MEMO

PPA Case No. 2015-001171PPA for 1524-1532 Ocean Avenue

Preliminary Project Assessment

Project Address: 1524 and 1532 Ocean Avenue

Preliminary Shadow Analysis:1524-1532 Ocean Avenue (ref: 2015-001250PPA) Title:

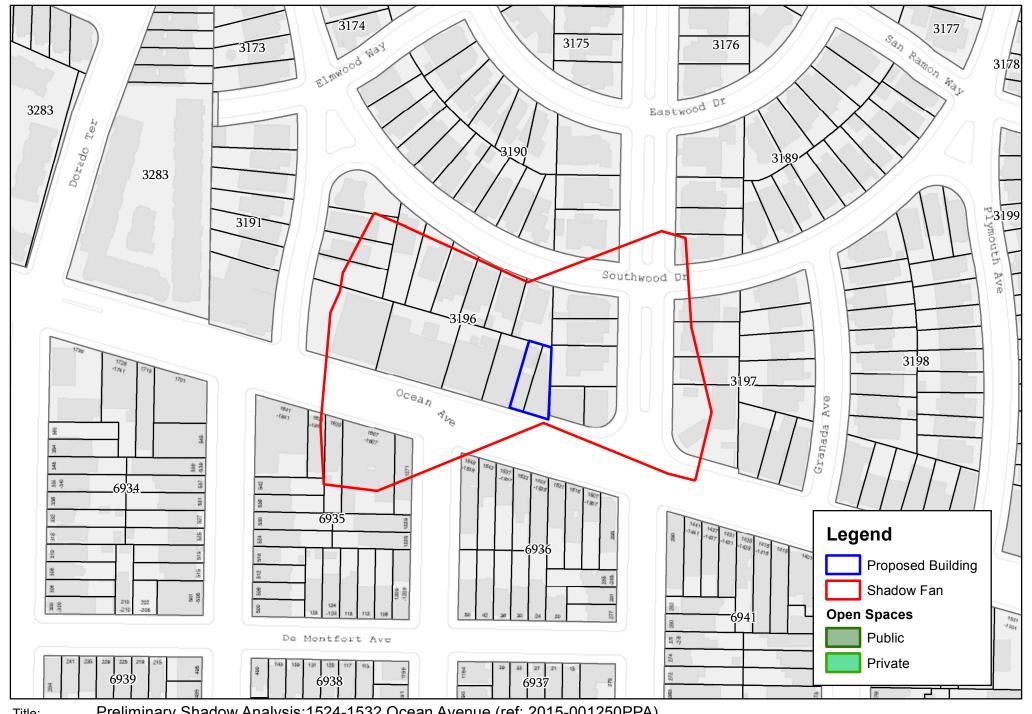
- 8. **Shadow.** The proposed project would result in construction of a building greater than 40 feet in height. A preliminary shadow fan analysis prepared by Planning Department staff indicates that the project would not cast new shadow on recreational resources. Therefore, no shadow study is required.

Proposed bldg height: 45 feet Comments:
